Re: Working Meeting for 65 Farm Road, Sherborn, MA

On April 29, 2024, a working meeting was held at the Sherborn Board of Health Office to discuss and clarify the remaining stormwater and septic design issues in the peer review correspondences.

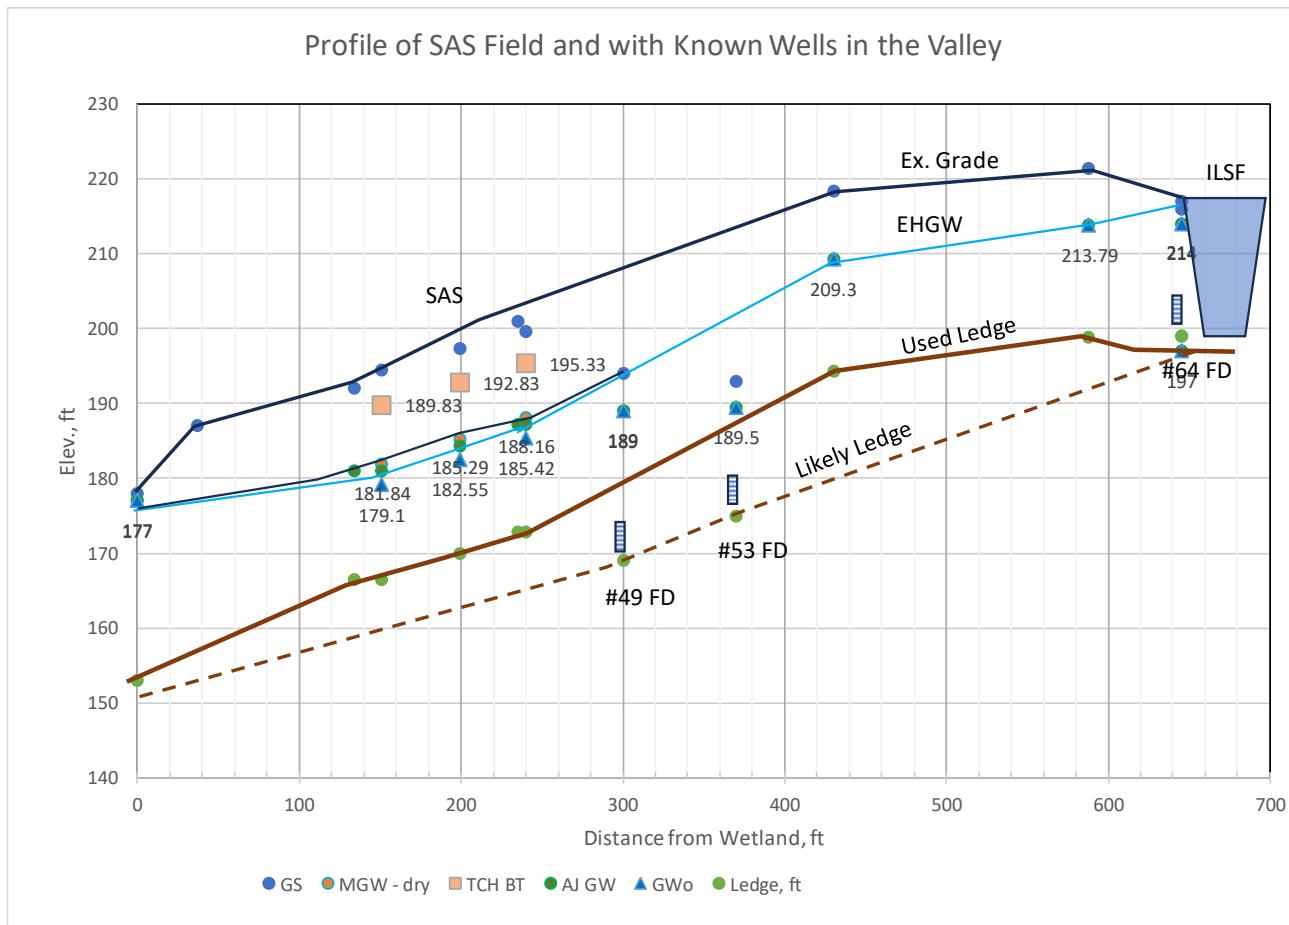
c. We reviewed and discussed the data CLAWE presented in their April 17, 2024 response letter, for the hydraulic conductivity analyzed using the widely accepted University Kansas HydrogeosieveXL excel sheet. We presented in our response letter dated April 17, 2024:

- i. The hydraulic conductivity analyzed using HydrogeosieveXL confirmed that the hydraulic conductivity values obtained from other source and methods for silty sand as we quoted from *Jay Ameratung, etc al. (2016) Correlations for soil and rock properties in Geotechnical Engineering, 28 ft/day*. The value of hydraulic conductivity used for early analysis was 24 ft/day, which is about 23% larger than the HydrogeosieveXL value of 19.46 ft/day, and about 86% of Ameratung's value 28 ft/day. It is well in between the range.

- ii. With all said above and detailed in our response to Comment 58, we took the conservative approach and reanalyzed the groundwater mounding using Hydrogeosieve XL value and saturated aquifer depth to be discussed in the following. The new groundwater mounding analysis in April 17, 2024 letter confirmed that the SAS and stormwater basins are designed in full compliance with applied Title 5 groundwater separation of 4 ft for SAS area and meet the dewatering requirement of 72 hours for stormwater basins.

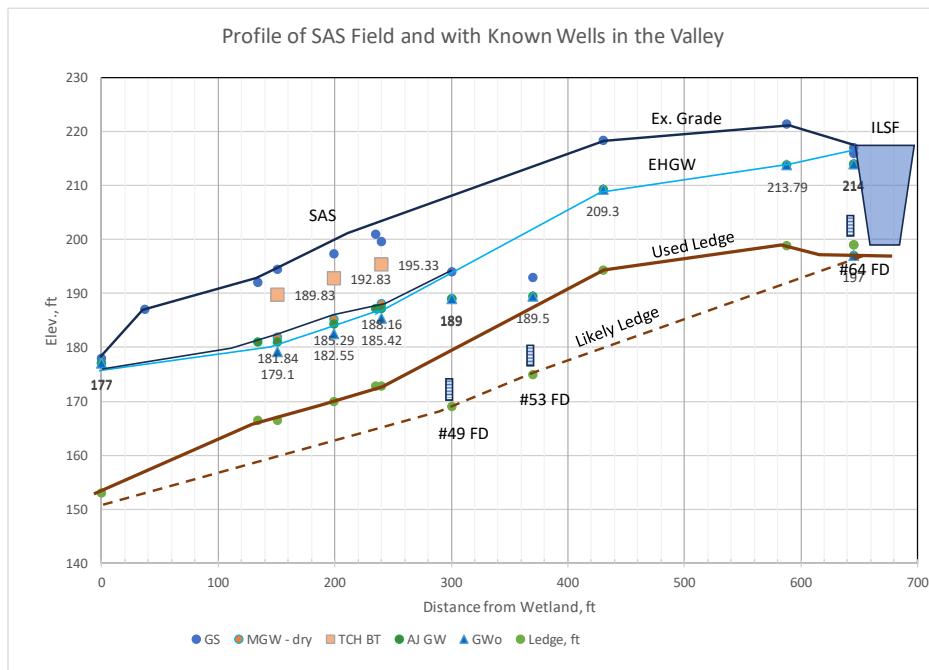
- vi. Based on the available data in the nearby area and the soil evaluation test pits in the leaching field (grade, and EHGW), we constructed a soil profile from the edge of the western wetland through the valley where SAS is located and to the upper ILSF area with reference to three drilled deep bedrock wells at 49, 53, and 64 Farm Road. See the following diagram for details.

As we can see from the diagram analysis, the overburden aquifer in the valley where SAS is located is likely in the range of 15 ft to 17 ft as they are located in the downgradient area of the reference wells and the ILSF which have a saturated depth ranging from 14.5 ft to 21 ft. Again, to be conservative, we used 14.5 ft for the saturated aquifer depth for the estimated high groundwater condition for the groundwater mounding analysis for the SAS area. It should be noted that this value is not just for the SAS area but would be expanded hundreds feet beyond into the downgradient area, which shows an average aquifer depth of over 19.59 ft based on 41 DEP wells drilling data analysis.
